**Coal Combustion Waste Impoundment
Dam Assessment Report**

*Site 7
1982 Pond & 1964 Pond
Progress Energy Carolinas
Asheville, North Carolina*

**Project # 0-381
Assessment of Dam Safety
Coal Combustion Surface Impoundments
For the REAC Program**

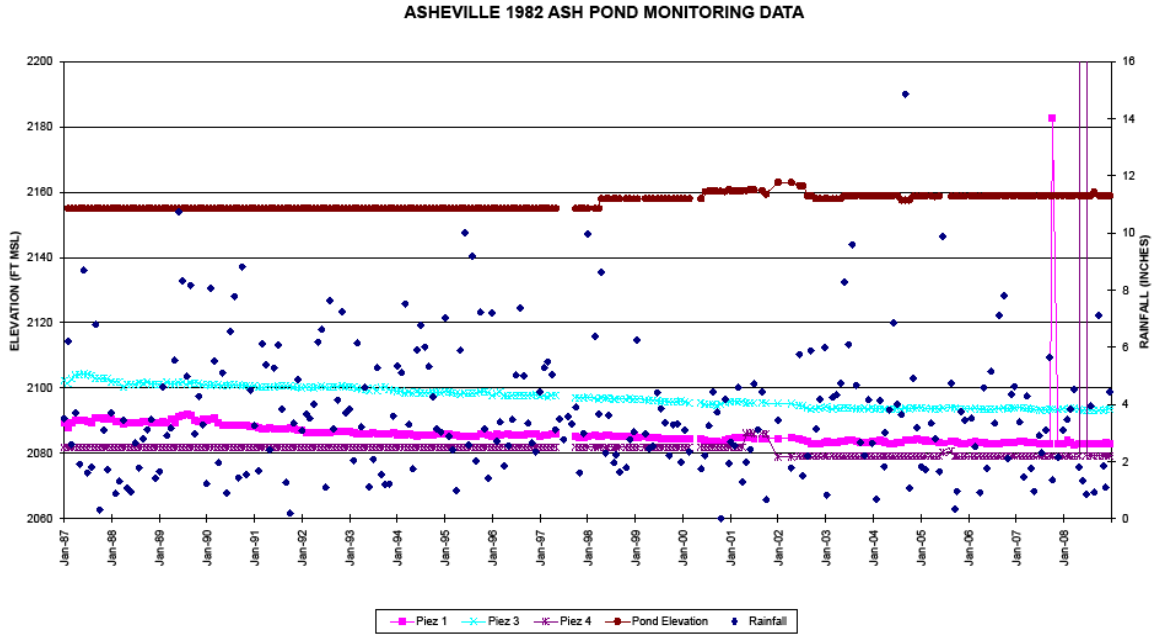
Data taken from Stability Model – Downstream Slope – 1982 Ash Pond Dam provided by Progress Energy dated May 2007, see Appendix A – Doc 17 (Exhibit 12).

1982 Dam – No uplift calculations were provided. Based off the Stability Model – Downstream Slope – 1982 Ash Pond Dam drawing (See Appendix A – Doc 17 [Exhibit 12]), the assumed phreatic surface is consistent with the Piezometer readings. Assumptions on the phreatic surface were based on the Stability Model referenced above. In the 5 year report from Progress Energy Carolinas, it stated that the 2007 piezometer readings remained consistent with “the historic trend.” The only changes in the readings were consistent with when the pond level was dropped to its current elevation of 2159 feet in August 2002. In October 2001 the pond elevation was at 2162 feet and in July 2002 the elevation was at 2163 feet. See

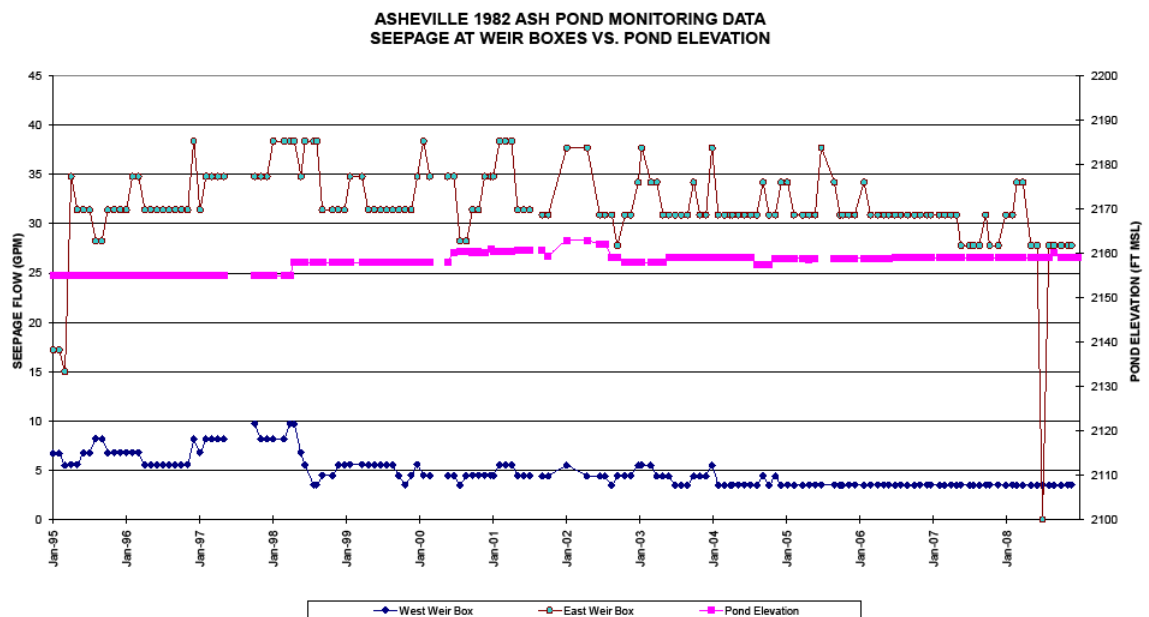
1982 Dam – A seepage collector box with a V-notch weir and measuring gauge is located at the toe of the slope at the outlets of the internal drains. Points of seepage flow are measured or estimated. Internal drain outlets are visually inspected for proper function. A ruler is then used to measure the height of the flow above the weir, at each internal drain outlet pipe, to the nearest 1/8 inch at weir location and correlated to flowrate. Four piezometers are located within the upper half of the downstream slope. For piezometer readings, a water level indicator probe is used, which is lowered within the monitoring well

until water is reached, and the distance is recorded. Please refer to Appendix A, Doc 17 Asheville S.E.P. – Ash Pond Expansion, Dam Plan & Profile for locations of the seepage collector box and piezometers.
